South Texas Project  
Units 3 and 4  
Docket Nos. 52-012 and 52-013  
Supplemental Response to Request for Additional Information

Attachment: RAI 03.07.01-24, Supplement 1, Revision 1

**RAI 03.07.01-24****QUESTION:****(Follow-up Question to RAI 03.07.01-14)**

Figure 03.07.01-24b: Comparison of Response Spectra, Reactor Building, RPV/MS Nozzle

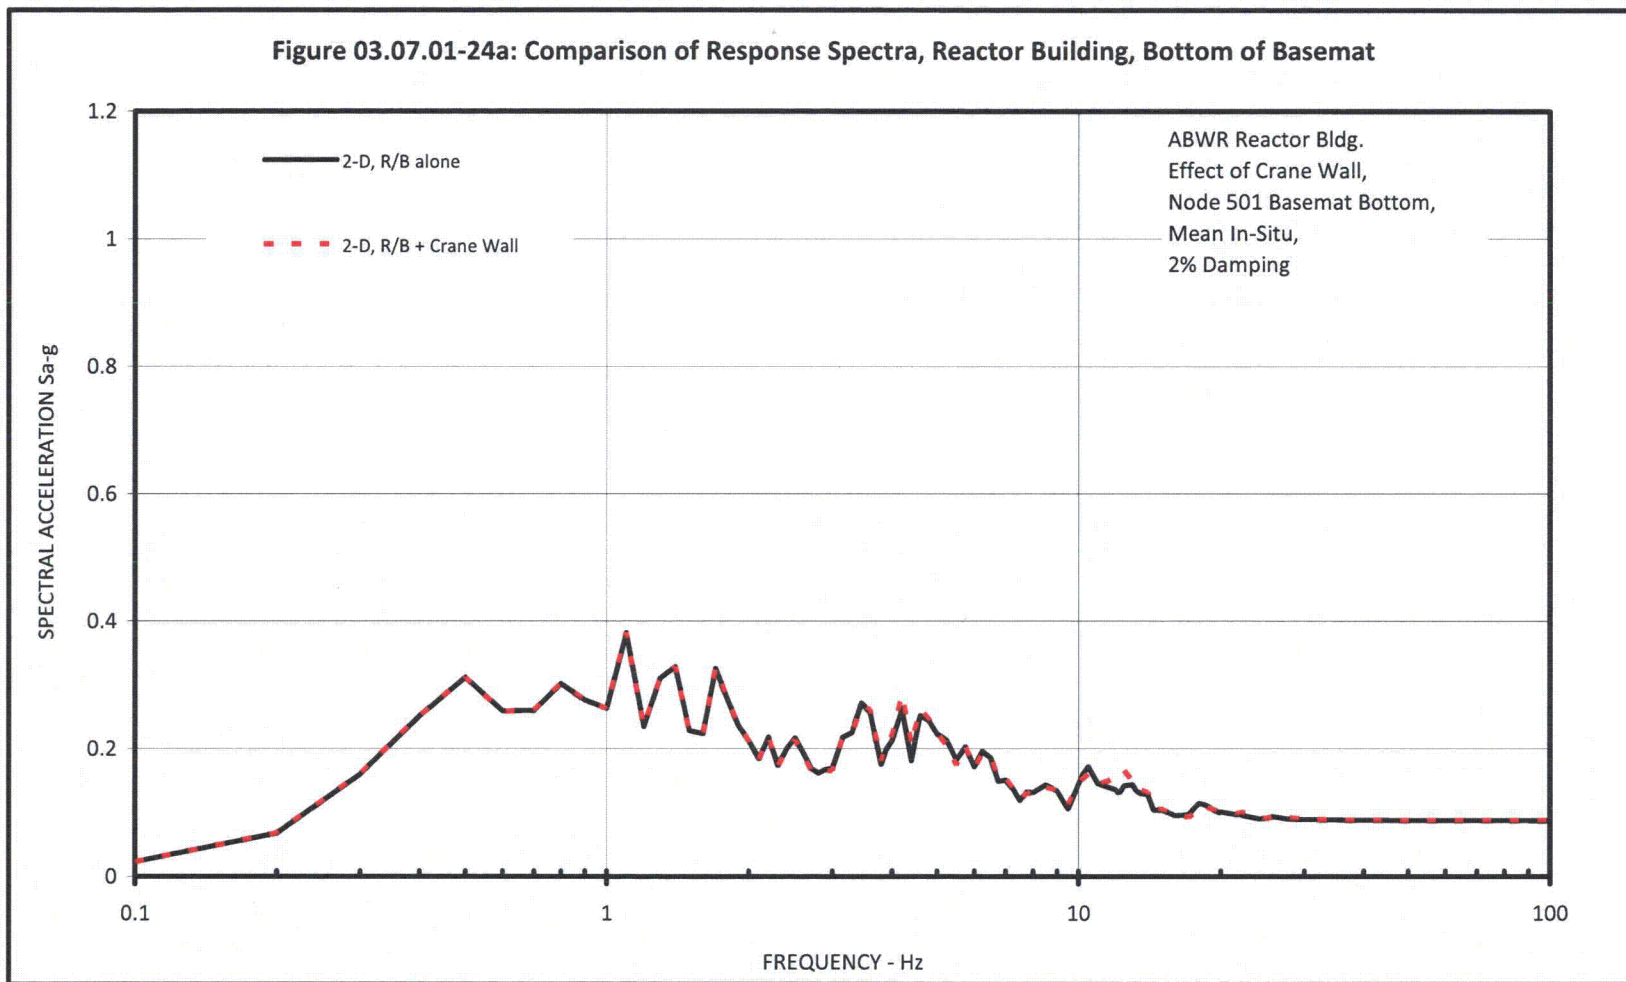
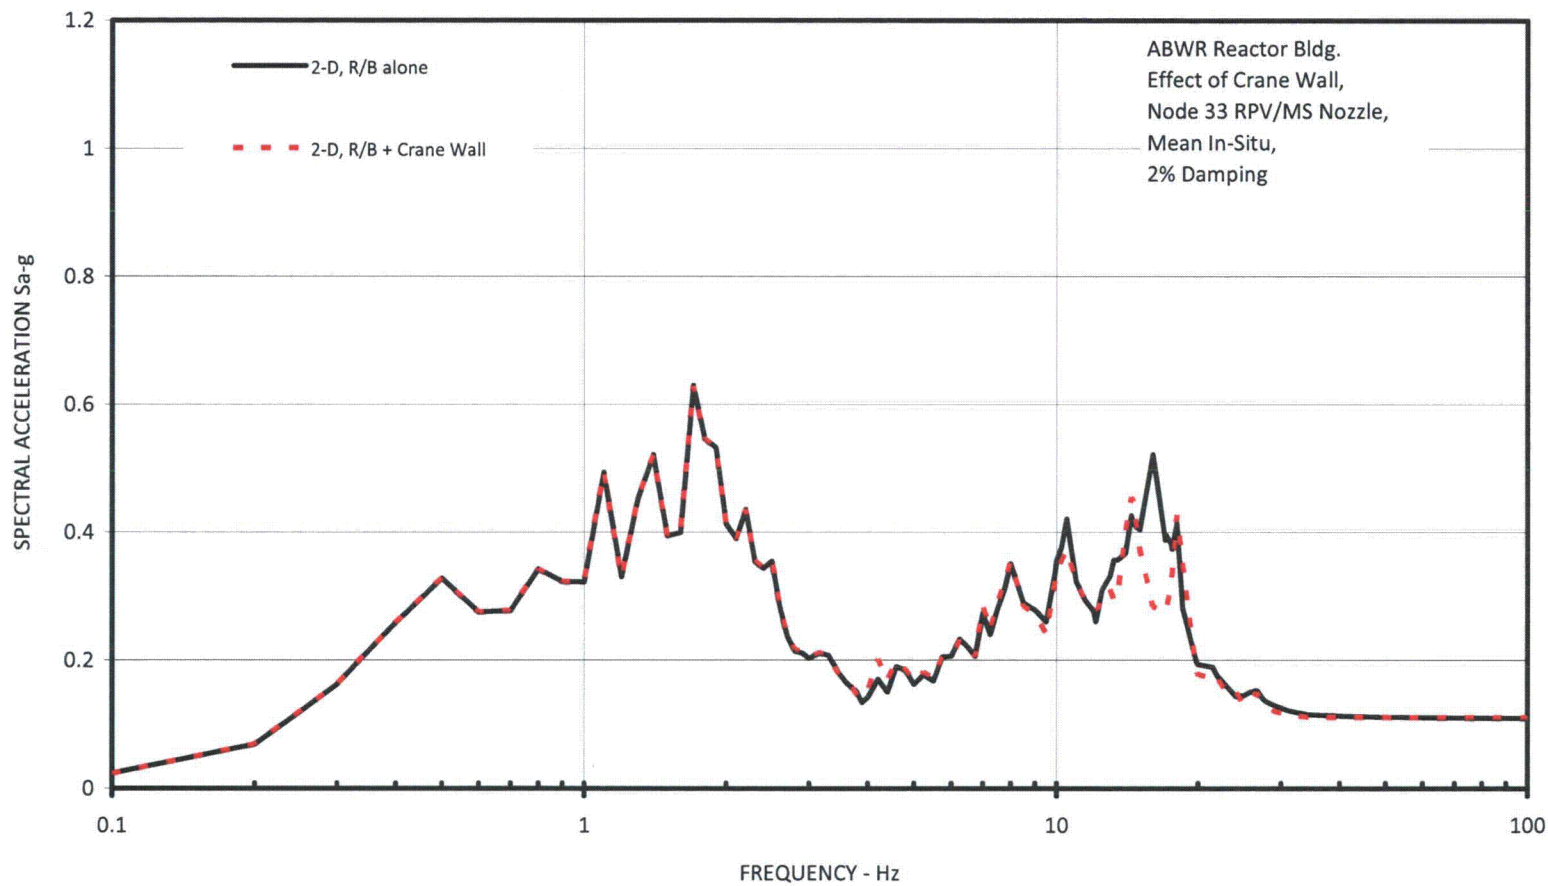
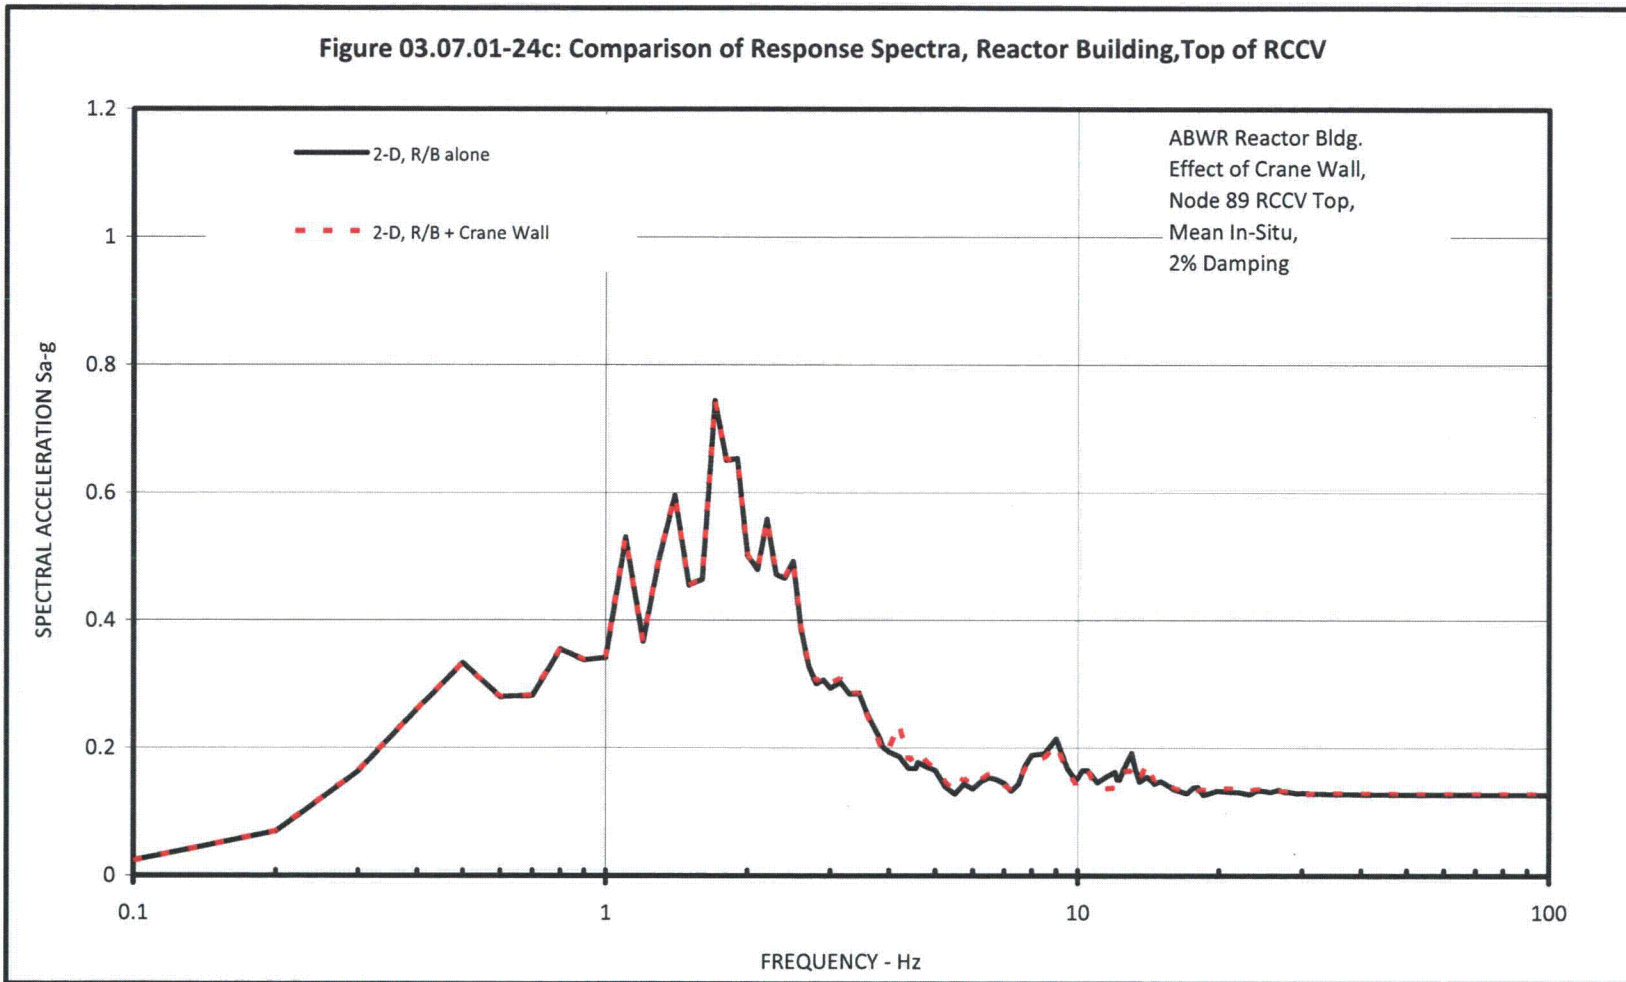
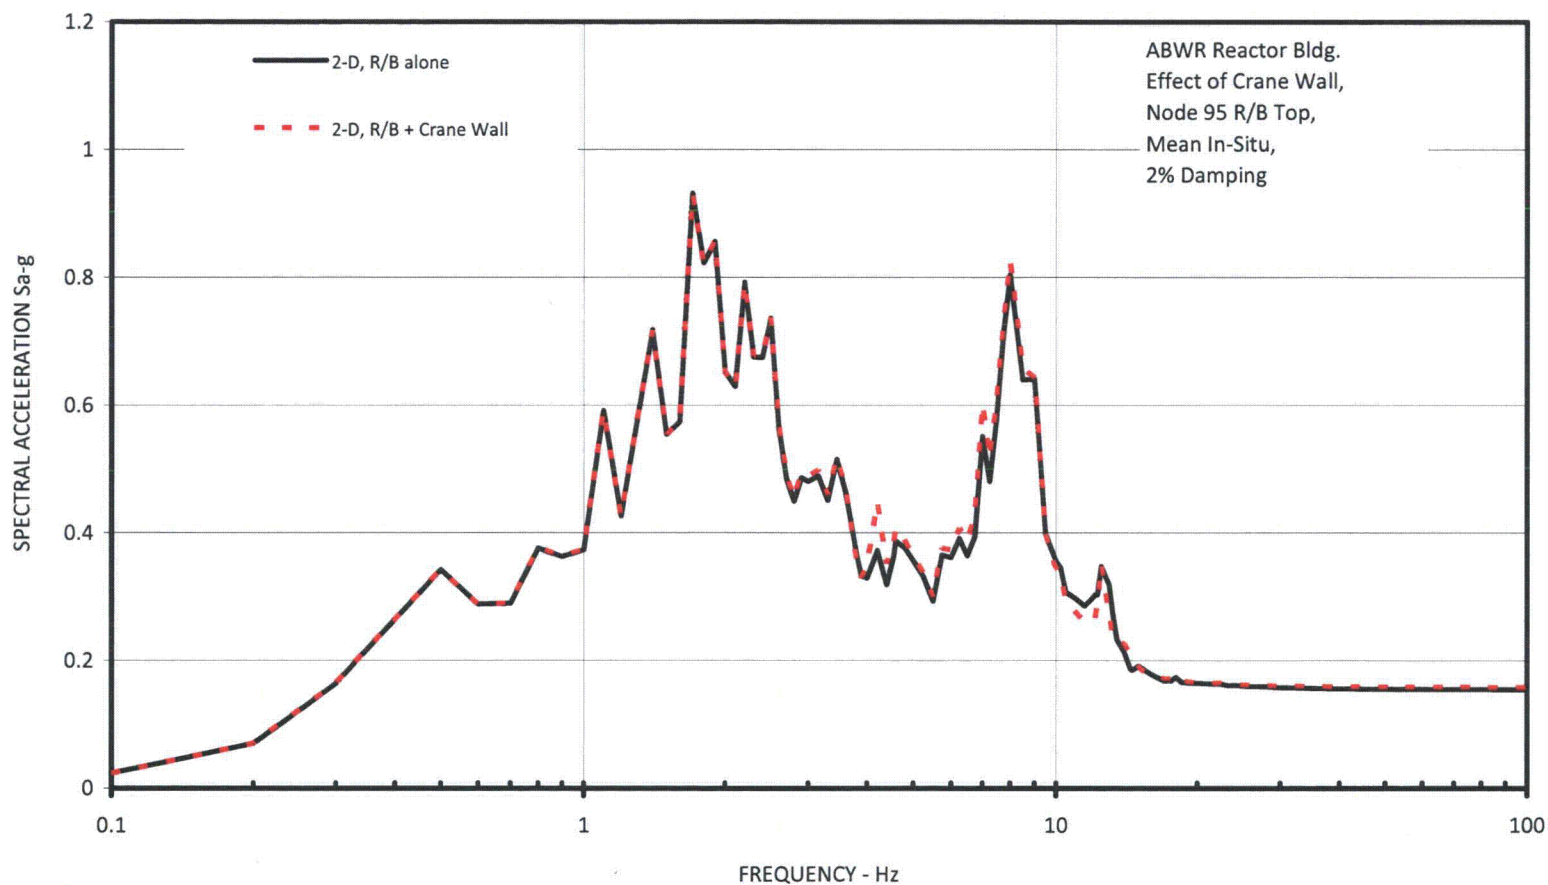
2. In the response to RAI 03.07.01-14, Item 2, the applicant stated in the second bullet that “***In comparison to the Reactor, Control and Turbine Buildings, the retaining wall is a light structure and a lighter structure will have less influence on the seismic behavior of the heavy adjacent structures.***” While the inertia of the RC retaining wall is not expected to affect the seismic response of the adjacent seismic Category I structures, the stiff retaining wall can act as a barrier to reflect the seismic waves due to kinematic interaction with surrounding soil and could affect the seismic input to the adjacent structures. As such, the applicant is requested to provide a quantitative assessment of the effect of RC retaining wall on the SSI analysis of adjacent Reactor and Control Buildings.

- Table 03.07.01-24a compares the maximum forces and moments, at key locations of the R/B, with and without the crane wall. As can be seen, the crane wall has a negligible effect on the resulting maximum forces and moments.
- Figures 03.07.01-24a through 03.07.01-24d provide comparisons of response spectra at several locations with and without the crane wall. As can be seen, the crane wall has a negligible effect on the resulting spectra.
- Figure 03.07.01-24e provides the comparison of the resulting seismic soil pressures from the SSI analyses with and without the crane wall. As expected, these seismic lateral soil pressures are significantly bounded by the design seismic soil pressure per DCD Tier 2, Figure 3H.1-11 and pressure obtained from the alternate modified Ostadan method described in COLA Part 2, Tier 2, Section 2.5S.4.10.5.2.

Figure 03.07.01-24e  
Reactor Building Site Specific  
At-Rest Seismic Lateral Earth Pressure (psf)  
Multiple Methods Displayed

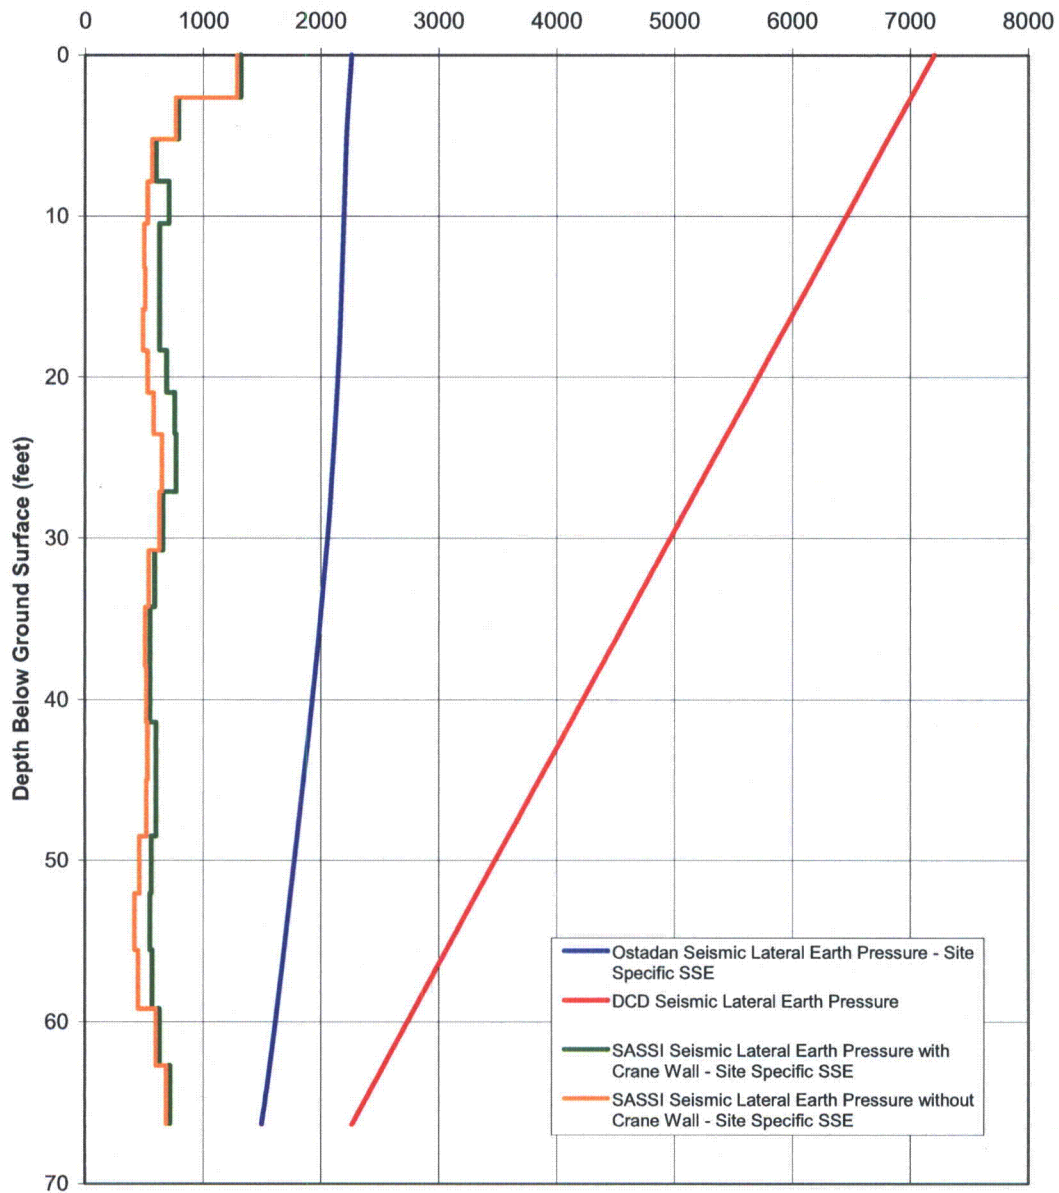
1. In the response to RAI 03.07.01-14, Item 1, the applicant cited DCD Appendix 3A in concluding that “... ***the potential effect of structure-to-structure interaction was relatively small.***” However, DCD Section 3A.9.7, “Effect of Adjacent Buildings” also concluded that seismic soil pressure in between the RB and CB increased due to structure-to-structure interaction (SSSI) effect. As such the applicant is requested to discuss how the potential effects of increase in the seismic soil pressure in between the Category 1 structures and the retaining wall due to the SSSI effect has been addressed and bounded by the certified design.
